STAFF REPORT: 12-11-2019 MEETING
APPLICATION NUMBER: 19-6538
ADDRESS: 3960 THIRD
HISTORIC DISTRICT: WILLIS-SELDEN
APPLICANT: BOB GEORGE
DATE OF COMPLETE APPLICATION: 10/30/2019
DATE OF STAFF SITE VISIT: 10/29/2019

SCOPE: ADD STOREFRONT, DOORS AND WINDOWS

THIRD STREET BUILDING RENOVATION

Existing Roof and Clerestory. Roof doesn't have a parapet, rather it angles up on each side to a center flat roof. Therefore, any roofing product will be visible.

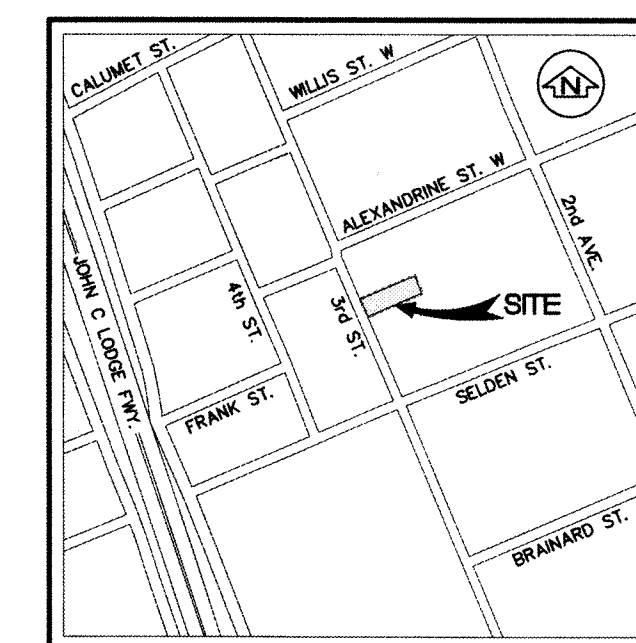
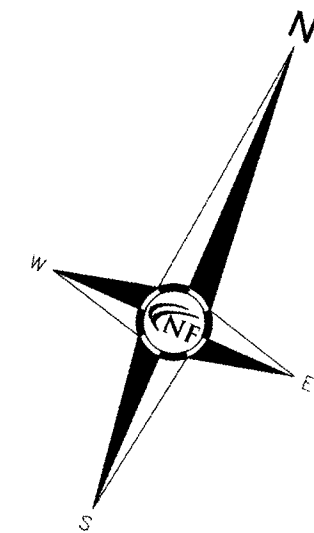
- The color will change from a standard black rolled roofing, to a beige spray-on roof.
- Confirmation is needed that the new windows will match the specifications for the storefront windows planned on the front elevation.
- Specifications for the Hardie panels were not submitted.

- Specifications for the clerestory storefront windows will be submitted.
- The silicone applied to the Energy Shield spray foam roof will be gray (S2022).

FLOOR PLAN

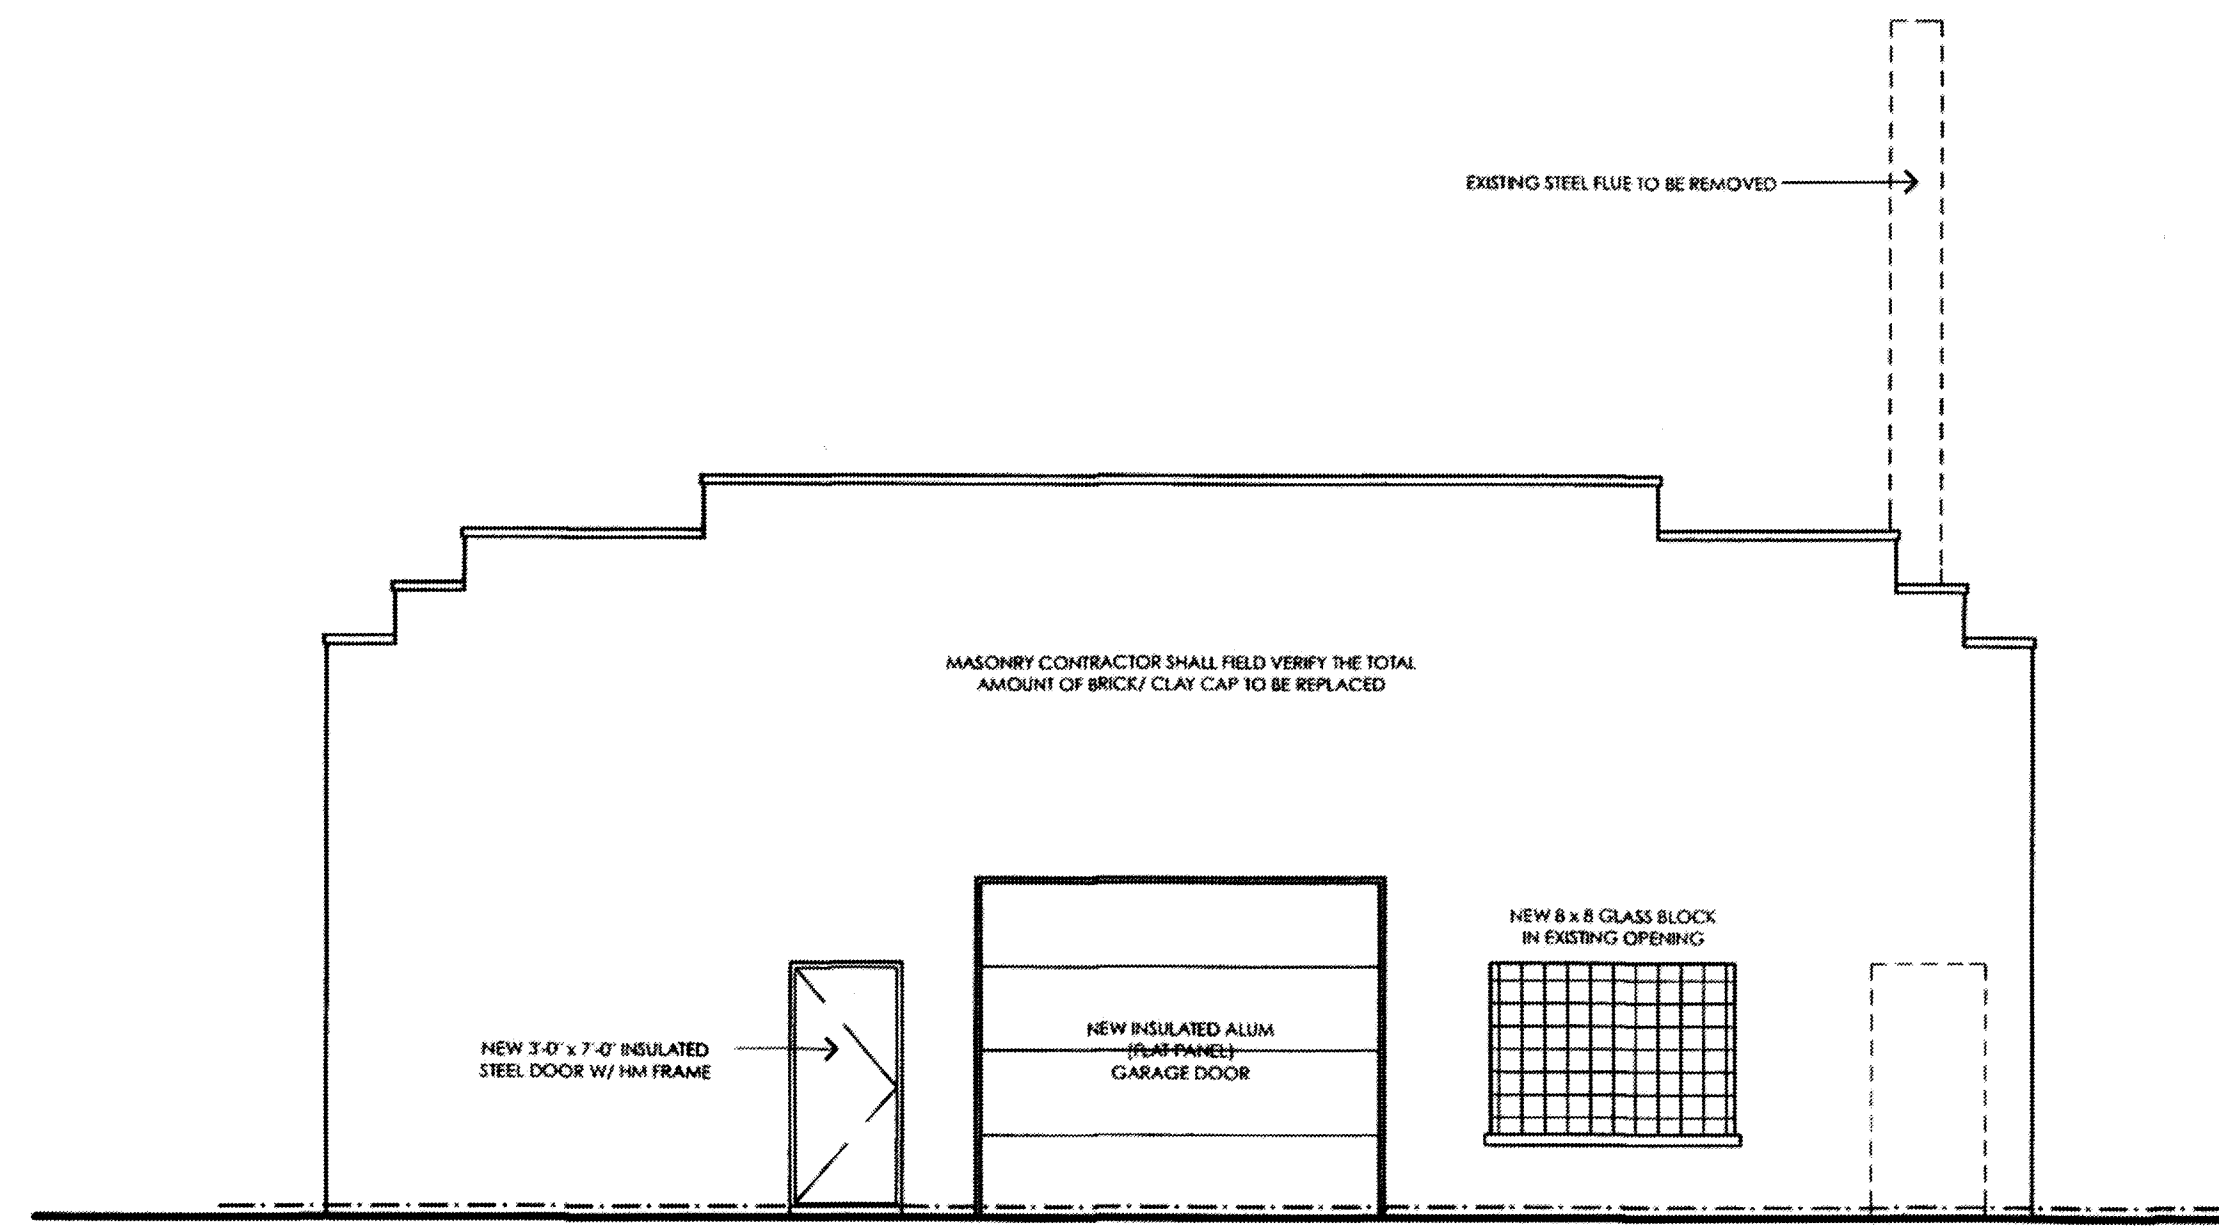
- The work specification states “paint top portion of west elevation”, however the elevation drawing states “all existing brick to be re-painted (this façade only).
- The plans contradict where the new entry door will be placed. The floor plan and elevation show a recessed entry, however the plumbing/mechanical/electrical plans show the door flush with the storefront opening and located to the far left.
- Assuming the floor plan is the accurate version, the relocation of the door creates a recessed alcove.
- The brick below the sills offer a quiet, unified appearance to the front elevation and may be an original building component. The applicant has not given a reason for the brick’s removal.

- The left-side storefront design will match the floor plan indicated on the mechanical/electrical/plumbing plans, i.e., the door and window unit will be flush with the storefront folding units.

- The brick below the sills will remain. Additionally, the brick removed from the area where the new door will be constructed will be saved and reused, as is possible, to fill in the area below the sill that will be enclosed upon the removal of the existing door.

NORTH ELEVATION
 SCALE: 1/4" = 1'-0"

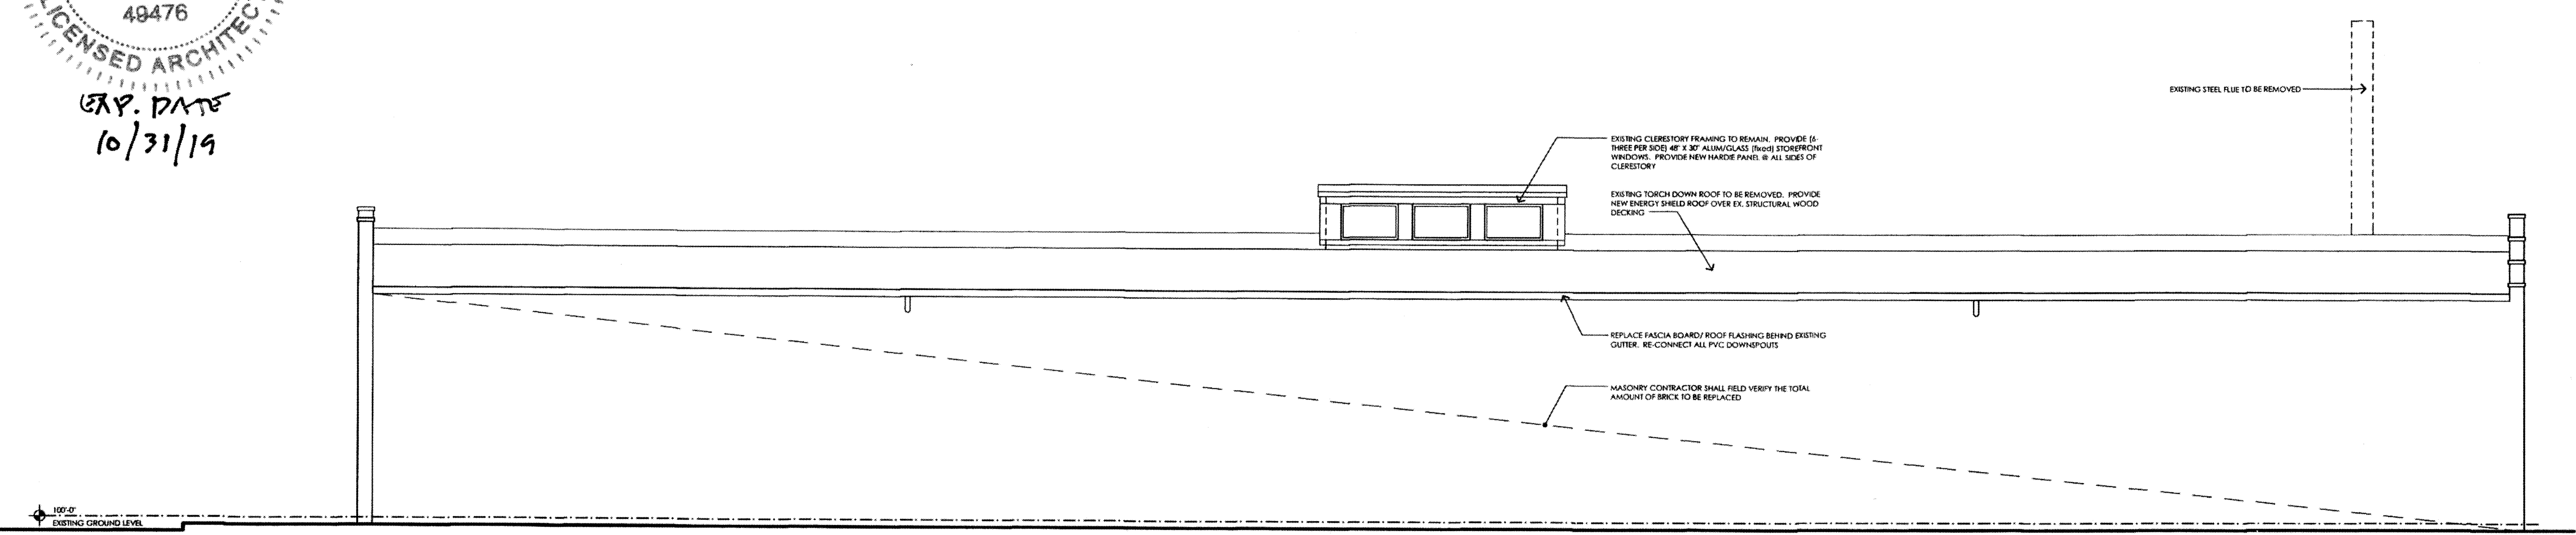
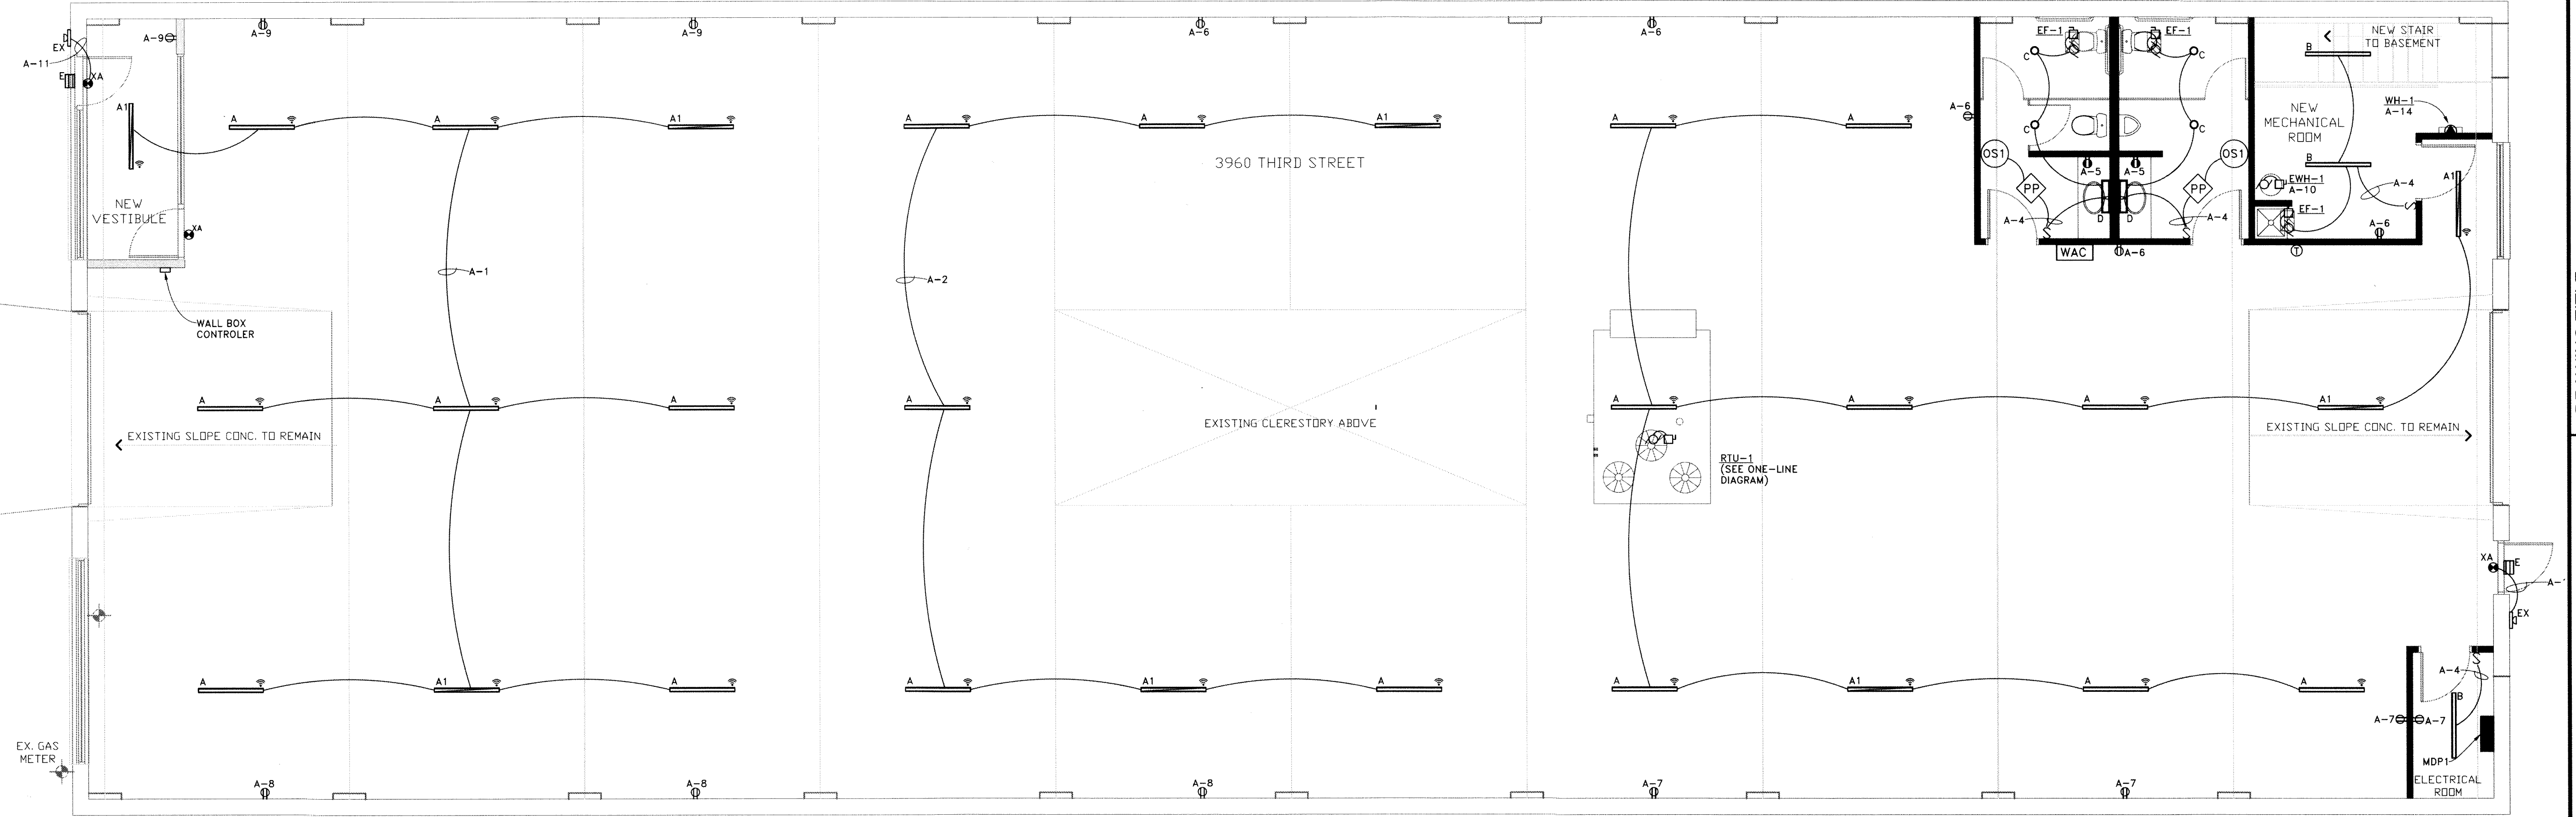
- The existing patch jobs and partial replacement of the brick will potentially cause further deterioration if not addressed. Mortar appropriate for historic brick is much softer than mortar purchased off the shelf (similarly, the old bricks are much softer than new bricks). Mixing in almost half of a wall of new brick/mortar may exacerbate the deterioration of the original brick (as water will run through, and then freeze within, the softest materials on the walls). Speaking with an experienced mason is suggested.
- The pattern of the glass block hasn’t been specified.

- The existing condition and long-term care of the masonry side walls be investigated further with a detailed repair plan per the recommendations of a licensed mason.

- New brick shall match the existing brick in color, dimension, texture and pattern. A historic mortar mix shall be used, even if new brick (rather than reclaimed historic brick) is used. Please refer to the National Park Service Technical Preservation Services Preservation Brief “*Repointing Mortar Joints in Historic Masonry Buildings*”.
